APPLICATION NO.	FILING DATE	FIRST NAMED INVENTOR	ATTORNEY DOCKET NO.	CONFIRMATION NO.
09/868,938	07/18/2001	Kiyoshi Nishio		4331

**Office Action Summary**

**DETAILED ACTION**

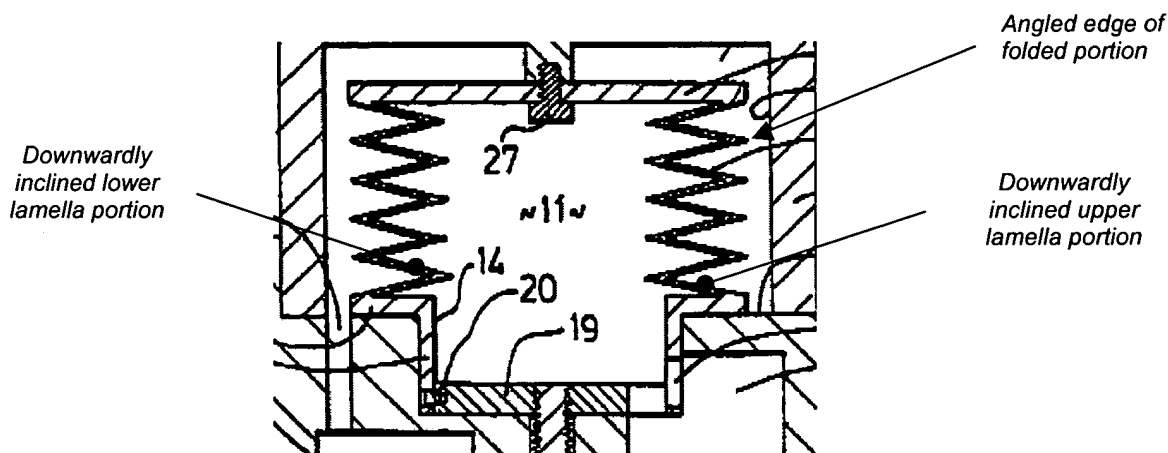
2. Claims 7 and 10 are rejected under 35 U.S.C. 103(a) as being unpatentable over Thomin et al. (WO 99/31388) in view of Boedecker et al. (4,655,690). Thomin et al. teach a fluid apparatus having a bellows 12 with extending and contracting portions configured by forming ridge-like folds and valley-like folds 18 in a vertically alternate and continuous manner, that are extendingly and contractingly deformable in an axial direction. The bellows are placed in a pump body 1 such that the axial direction defines a vertical axis. Figure 2 illustrates an inner pumping chamber 11 (corresponding to the claimed liquid chamber) formed inside of bellows 12; an outer pumping chamber 10 (corresponding to the claimed air chamber) formed outside of the bellows 12; and a suction (or inflow, as in claim 4) port 43 and a discharge (or outflow, as in claim 4) port 45 formed in an inner bottom face of the pump body facing the inner pumping chamber. Figure 2 further illustrates that the bellows are formed into a shape in which a lower one

of upper and lower lamella portions of each of the ridge-like folds is downwardly inclined toward the vertical axis, in both the extending and contracting state (see the accompanying figure), and in the contracting state, the upper and lower lamella portion of each ridge-like fold is formed to be downwardly inclined.

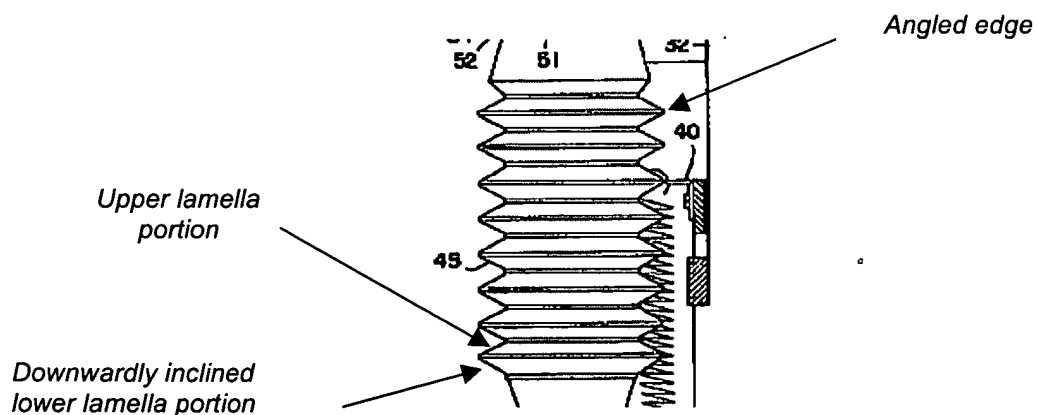
3. Claims 7 and 10 are rejected under 35 U.S.C. 103(a) as being unpatentable over Hope et al. (4,231,724) in view of Boedecker et al. Hope et al. teach a fluid apparatus having a bellows 45 configured by a pump in which a bellows that has an extending and contracting portion configured by forming ridge-like folds and valley-like folds in a vertically alternate and continuous manner (see column 5, lines 7-13), and that is extendingly and contractingly deformable in an axial direction. The bellows 45 are placed in a main frame 12 (corresponding to the claimed pump body) such that the axial direction extends along a vertical axis, and include a chamber inside of the bellows. Hope et al. further teach a suction port 83 and a discharge port 63 and that the extending and contracting portion of the bellows is formed into a shape in which a lower one of upper and lower lamella portions of each of the ridge-like folds is downward inclined toward the vertical axis, in both the extending and contracting state (see the accompanying figure), and in the contracting state, the upper and lower lamella portion

of each ridge-like fold is formed to be downwardly inclined. With regards to claim 10, since the bellows are exposed to air, it stands to reason that there is an air chamber outside of the bellows. That is, outside of the bellows 4 and within main frame 12, constitutes the claimed air chamber.
